LAND USE APPLICATION - COMPLETENESS REVIEW

Subject Property:	1793 Silverton Road NE
Reference Number:	24-124647-PLN
Application Type:	Class 3 Site Plan Review and Class 2 Adjustment
Date Application Accepted:	December 12, 2024
Applicant:	Gretchen Stone (CBTwo Architects) gretchen@cbtwoarchitects.com
Contact:	Marcus Morin (Jet Industries) Marcus.m@jetindustries.net Oliver Raab (Jet Industries) Oliver.r@jetindustries.net

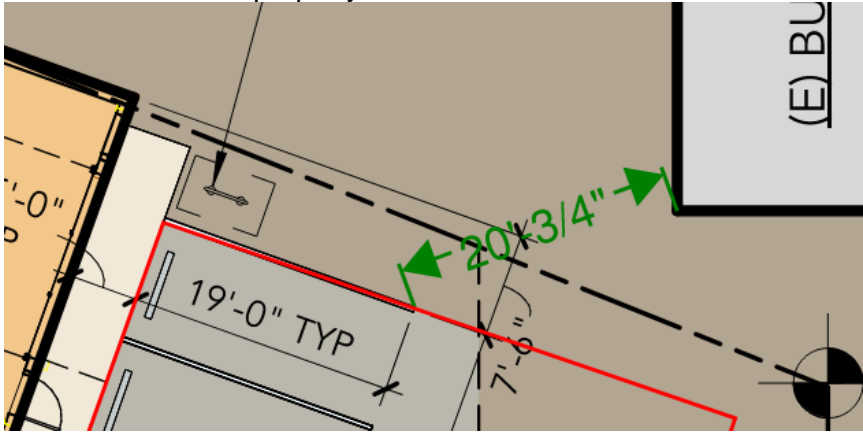
Vehicle Turnaround	<p>The area shown below terminates in a dead end. Per SRC 806.035(f), where a drive aisle terminates at a dead-end, a turnaround is required. Please revise the plans to provide a turnaround or reconfigure the parking area.</p> 	
Driveway Width	<p>SRC 806.040 (d) requires a minimum width of 22 feet for two-way driveways. The proposed parking space narrows the width of driveway used to access northern property to less than 22 feet. Please revise the plans to allow a 22-foot-wide driveway to allow</p>
